# Access Compliance Report

## Public Rights-of-Way

### (Curb Ramps)

Intersection ID: 49277	Main Street: REUNION_ST	Cross Street: HOMECOMING_WY	Location: SE
ADA ID: 69F41094393D	Ramp Type: PerpDiag	Initial Pass/Fail: Fail	Overall Compliance: No
		Severity Score: 25

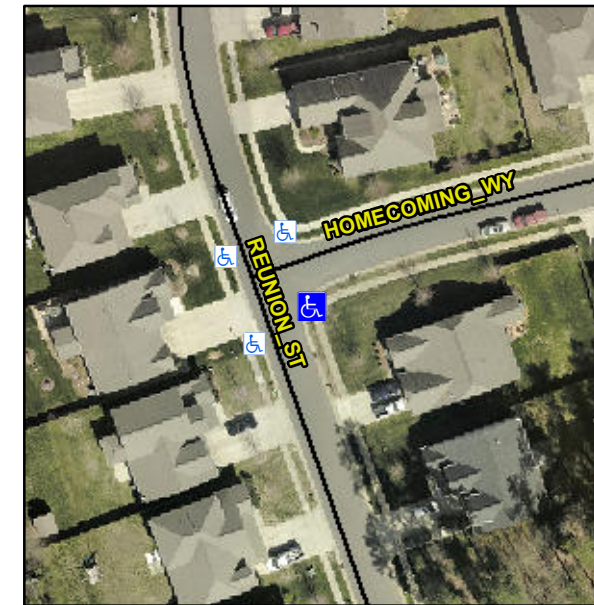
**R304.2.2**

Compliance	Description	Data	Compliance	Description	Data
N/A	Ramp Length (in)	46.0	No	Ramp Slope (%)	12.9
Yes	Ramp Width (in)	48.0	Yes	Ramp XSlope (%)	0.4
N/A	Flare Type LT	N/A	N/A	Flare Type RT	N/A
N/A	Flare Slope LT (%)	N/A	N/A	Flare Slope RT (%)	N/A
N/A	Flare Traversable LT?	N/A	N/A	Flare Traversable RT?	N/A
N/A	Landing Length (in)	N/A	N/A	DWS Provided?	N/A
N/A	Landing Width (in)	N/A	N/A	DWS Contrast?	N/A
N/A	Landing Slope (%)	N/A	N/A	DWS Length (in)	N/A
N/A	Landing X Slope (%)	N/A	N/A	DWS Full Width?	N/A
N/A	Landing Curb? (Y/N)	N/A	N/A	DWS Offset (in)	N/A
N/A	Shared Landing?	N/A			
N/A	Gutter Ponding?	N/A	N/A	Gutter Slope (%)	N/A
N/A	Gutter Lip Ht (in)	N/A	N/A	Gutter X Slope (%)	N/A
N/A	Painted X Walk1?	No	N/A	Painted X Walk2?	No
	X Walk 1 Direction	To N		X Walk 2 Direction	To W
N/A	X Walk 1 Width (in)	N/A	N/A	X Walk 2 Width (in)	N/A
	X Walk 1 Slope (%)	0.1		X Walk 2 Slope (%)	1.3
	X Walk 1 X Slope (%)	0.4		X Walk 2 X Slope (%)	1.2

**Remove & Replace Curb Ramp With Two New Directional Ramps or Equivalent.**
